Town of Lancaster
Planning Board
Lancaster, Massachusetts 01523

**Re: Peer Review - 90 Duval Road
Stormwater Permit- Third Party Review**

Site Inspection Report

To: Lancaster Conservation Commission and Lancaster Planning Board
From: Bob Hartzel, Comprehensive Environmental Inc. (CEI)
Re: 90 Duval Road
Date: October 29, 2021

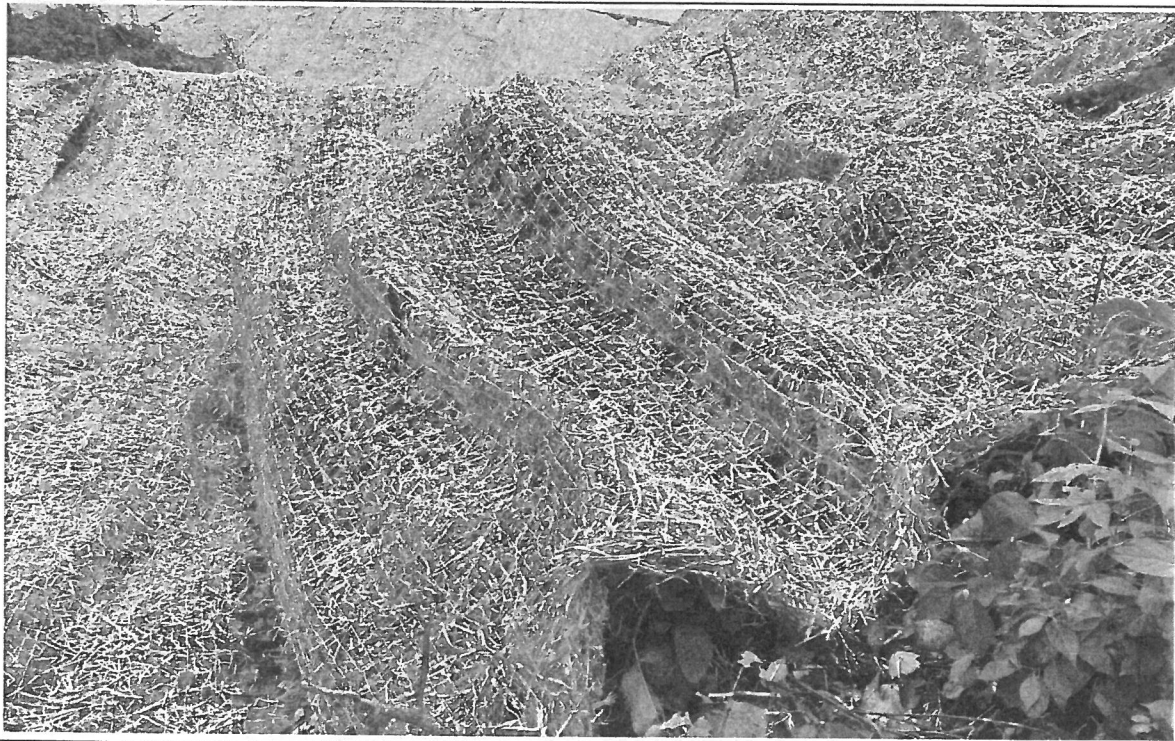
- **Hydroseed/Mulch:** A hydroseed/mulch mixture had been sprayed on a large portion of the site at the time of the inspection, predominantly in the areas upgradient of the stormwater basin and wetland buffer zone area. CEI and LDC discussed that it is likely too late in the season to expect much of the seed to germinate. As shown in Photo 1, the application of mulch associated with the hydroseed was thin and patchy in many areas. CEI recommends that this mulch will not provide adequate soil stabilization in areas where no other measures are currently in place or specified on the plans (i.e., all areas upgradient of the stormwater basin/buffer zone area). Additional stabilization measures should be installed in these areas.

CEI notes that the site plans do not provide a specific detail for hydroseeding on Sheet 401, and this is recommended. However, the "Slope Stabilization" detail on sheet C-401 of the site plans specifies "*Prepare surface by running tracked equipment up and down the slope, then apply hydroseed.*" As shown in Photo 1, it appears that hydroseed was applied in most areas with no surface preparation.

Photo 1: Hydroseed/mulch was applied, but had patchy ground coverage and was applied without surface preparation. The mulch is not expected to provide adequate stabilization for disturbed areas where no other measures are currently proposed. It is likely too late in the season to expect much of the seed to germinate.

Photo 6: View from wetland area near flag W20, towards point of discharge resulting from presence of berm. This area is currently protected only by several staked straw bales.

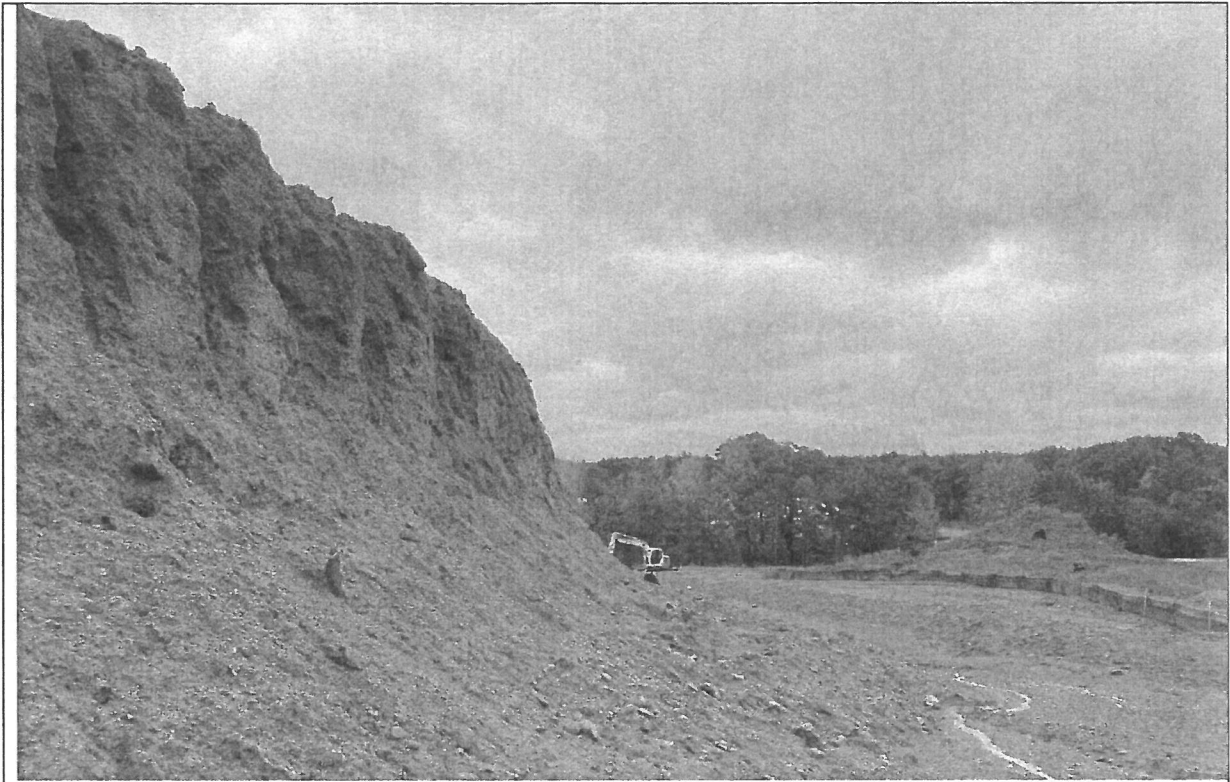
- CEI and LDC discussed the need for additional stabilization measures in the vicinity of wetland flag W20. A berm currently exists just upgradient of the wetland boundary (stumps and earthen material pulled away from the wetland boundary by previous contractor). Until this material is removed, the outfall of the proposed construction-phase stormwater basin cannot discharge with the intended flow path. It appears that the berm will result in a concentrated flow path that will discharge to the wetland near flag W20. Temporary stabilization/outfall protection measures should be added to ensure protection of the wetland in this area (Photo 6).

Sheet No.:
 L-101

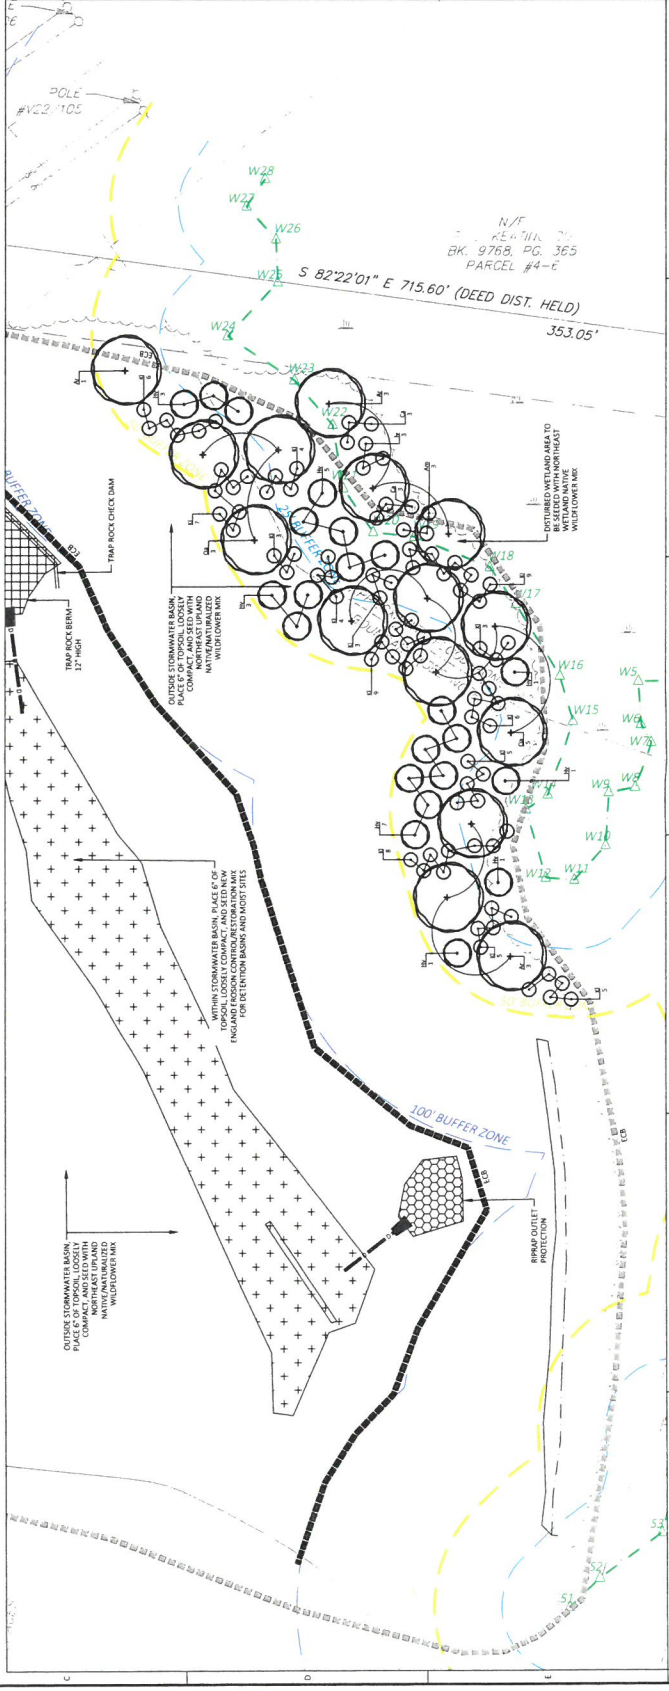
- 5) The Plans do not include a stabilized construction entrance or other measures to minimize off-site tracking of sediment.
- 6) The Plans do not include a wetland mitigation/restoration plan to address previous impacts to wetlands associated with discharge of sediment from the Site. A proposed wetland mitigation plan should be submitted for review to the Lancaster Conservation Commission.

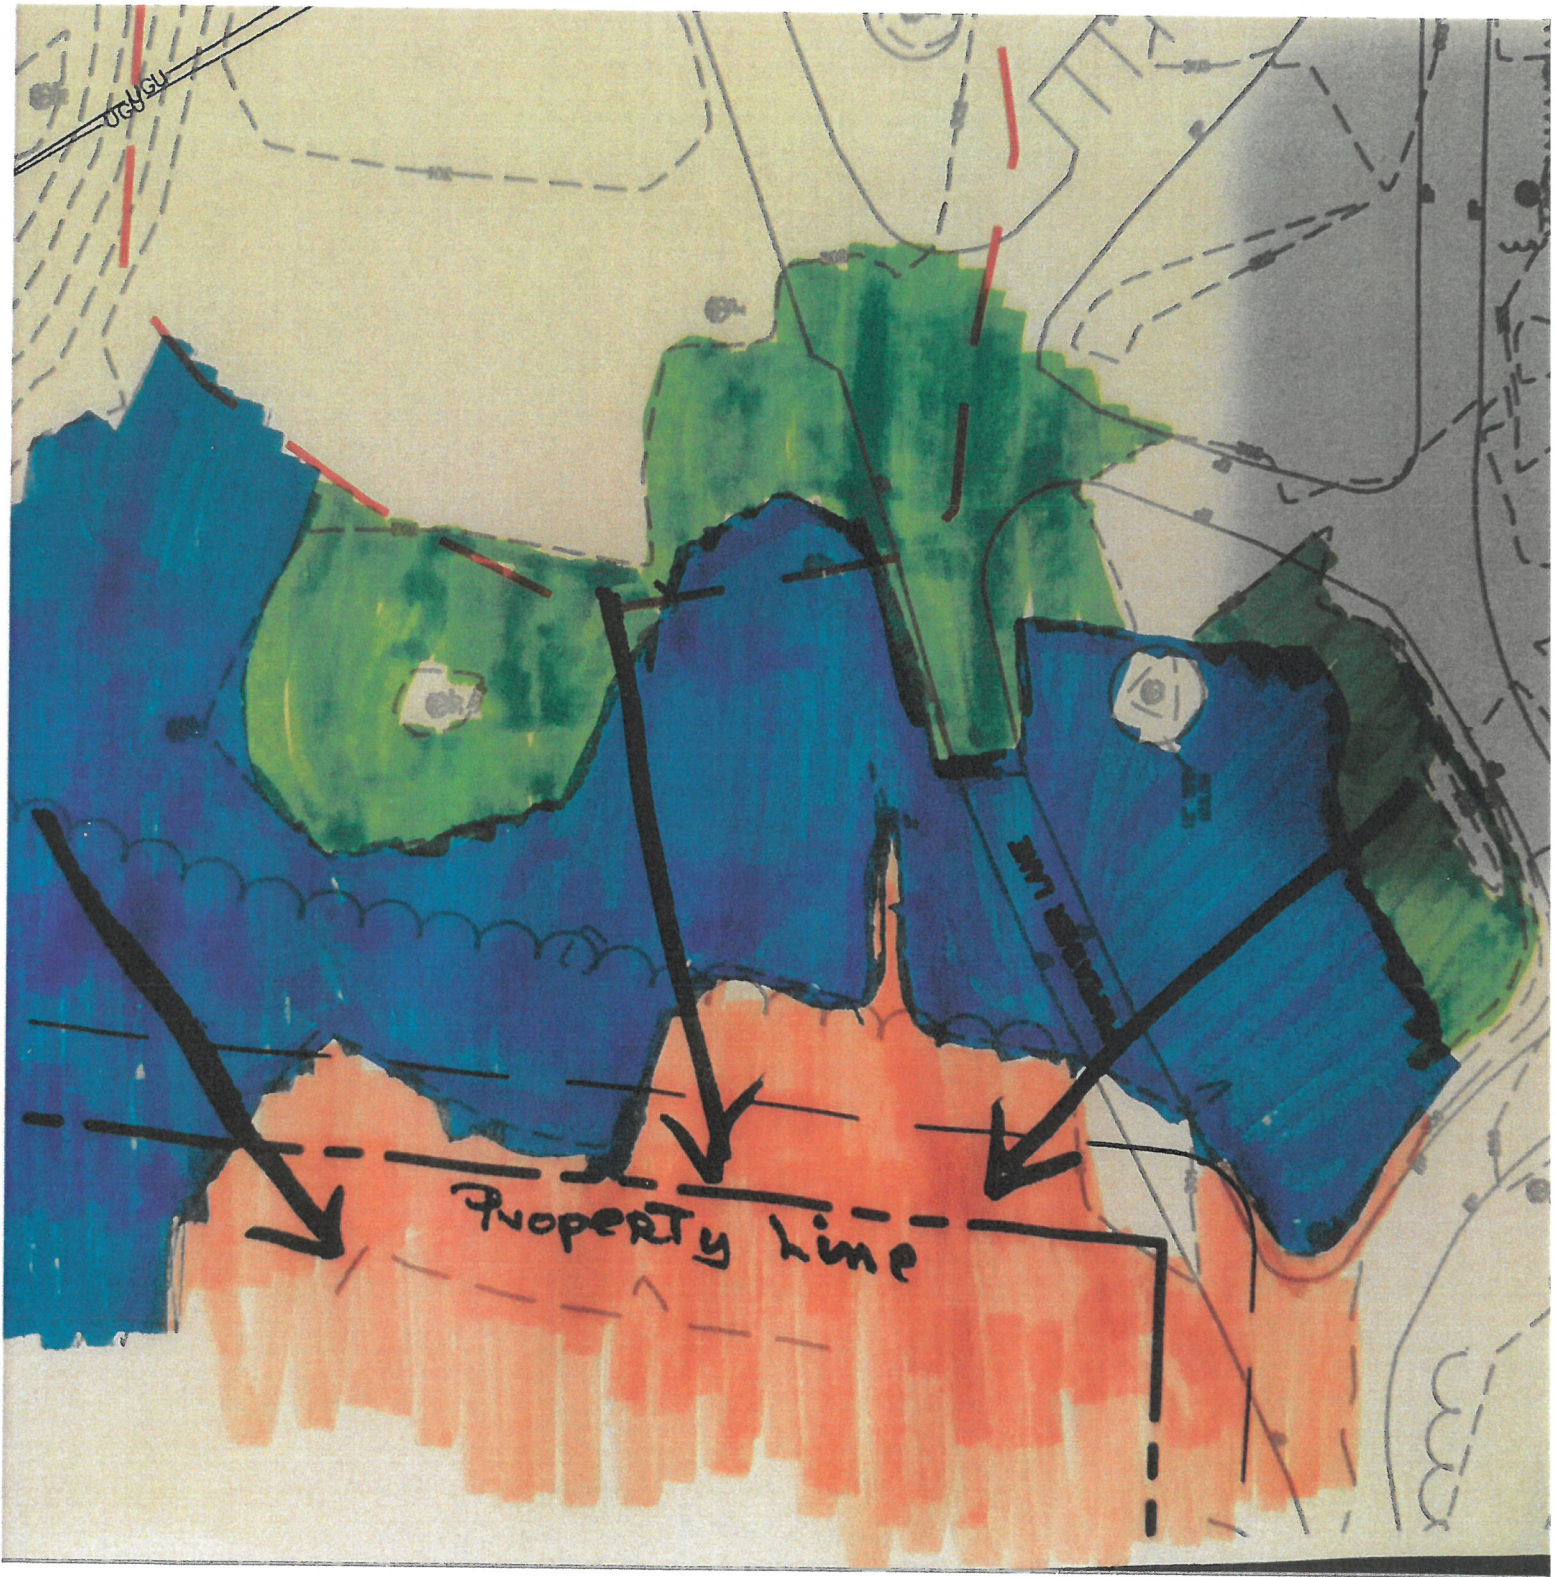
On a recent walk through the Perkins property, we noticed that there is a substantial berm/slope on the rerouted Pinfeather Lane that directs the water to our back property line.

I have attached two pictures to show what we are talking about. We are VERY concerned with the water impact on our property.

Orchard Hill Athletic impervious surface

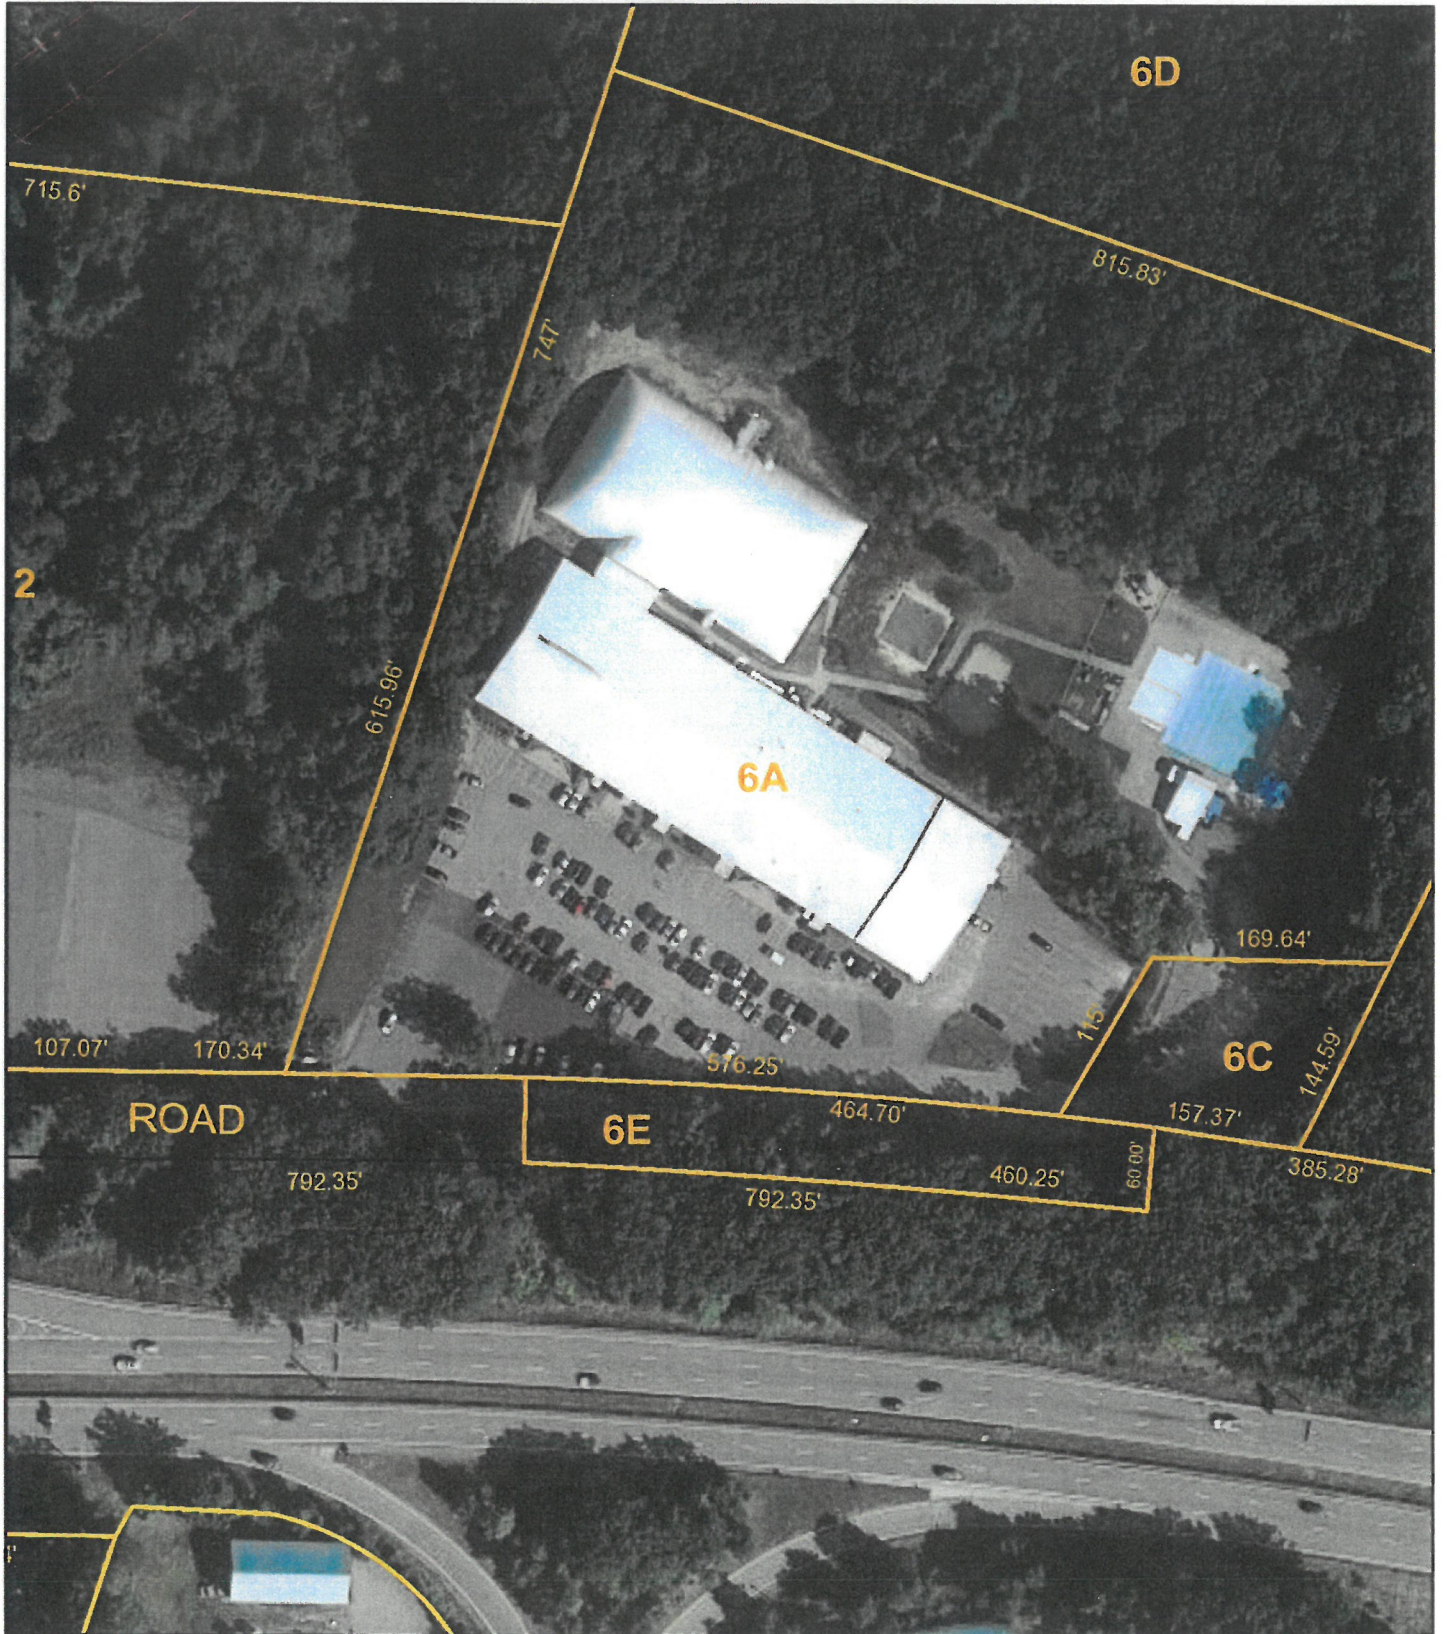
I'm asking that, if our current stormwater bylaw regs allow for it, that the Orchard Hill Athletic complex be reviewed for adequacy of stormwater treatment. I'm pretty sure that they have added impervious surface in expanding their parking footprint since our 2007 bylaw passed and that there is no current system to manage stormwater. Meanwhile, the current remediation evaluation and work at the U-Haul site that abuts suggests significant situation and water velocity issues emanating from the Site. Thank you for mulling over my request. Cara
